**Penrith Lakes Development
Corporation**

**S4.55 (2) VENM/ENM Importation
Modification: Submissions Report**

Issue | 28 September 2018

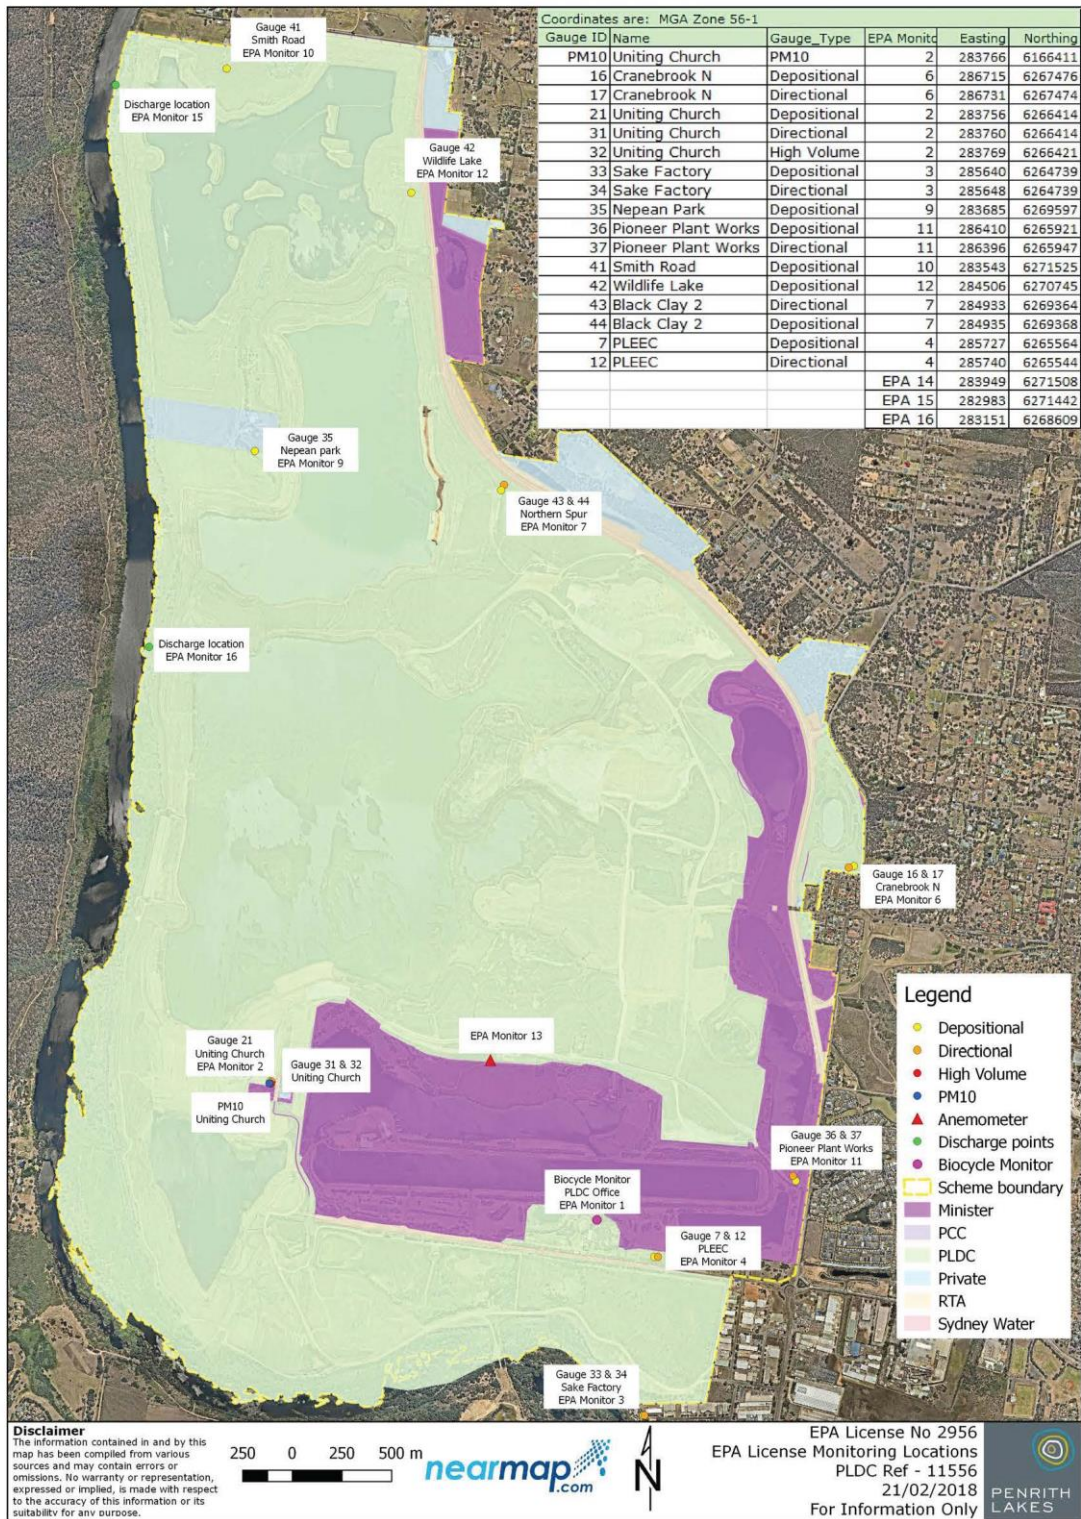
- (1) currently has dust monitor installed on property and would like to know if any health studies have been carried out regarding the dust and its affect on the community and what mitigation measures might be considered to eliminate dust along Castlereagh Road
- (2/10/20/38) raised concerns regarding the potential health hazard resulting from the increased amount of dust entering homes
- (4/8/9/12/14/18/19/33/36/40/41) raised concerns regarding the amount of dust currently experienced from the movement of trucks in and out of the site and impacts on property

PLDC Environmental Protection Licence No. 2956 requires air quality monitoring to be conducted at various locations around the Scheme.

There are three dust monitoring locations in close proximity to the existing VENM/ENM import operation – EPA Monitor 6 Cranebrook, EPA Monitor 7 Northern Spur and EPA Monitor 11 Pioneer Plant Works (as shown in Figure 1). Deposited matter is monitored on a monthly basis and must not exceed 4 grams per square meter per month expressed as an annual monthly average.

Over the past 3.5 years of VENM/ENM importation, there has been no exceedance of the annual monthly average during this period.
